# UNITED STATES PATENT AND TRADEMARK OFFICE

APPLICATION NO.	FILING DATE	FIRST NAMED INVENTOR	ATTORNEY DOCKET NO.	CONFIRMATION NO.
10/601,332	06/20/2003	Ubaldo Mastromatteo	2110-46-3	6985

**Office Action Summary**

Addendum B

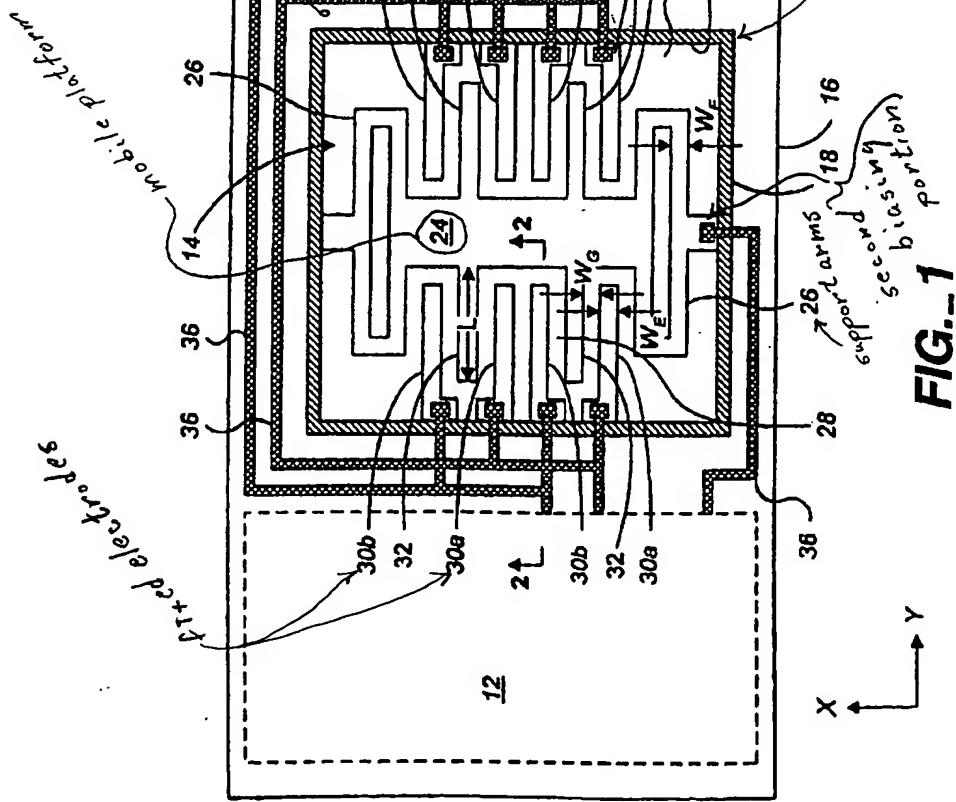
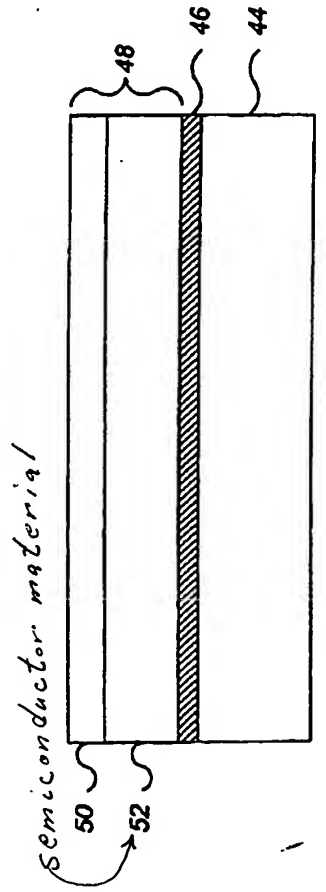
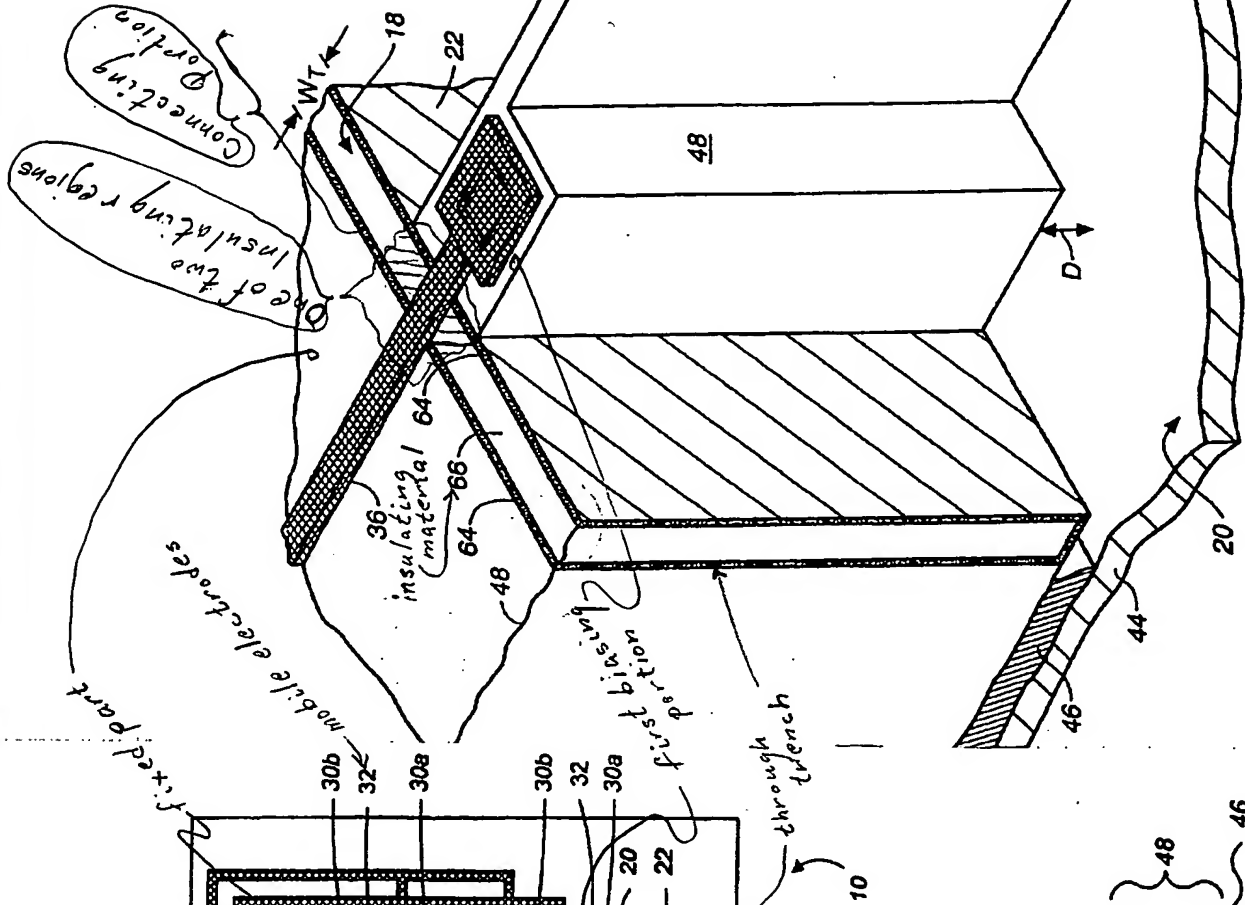
7. Claims 1-3,5-7,9,17-19 are rejected under 35 U.S.C. §102(b) as being anticipated by Brosnihan (PN 6,121,552; published 19 September 2000).

See Figures 1,3&4. Note, to the extent claimed and understood, the structure as shown in Addendum B reads on and performs to the same degree as claimed.
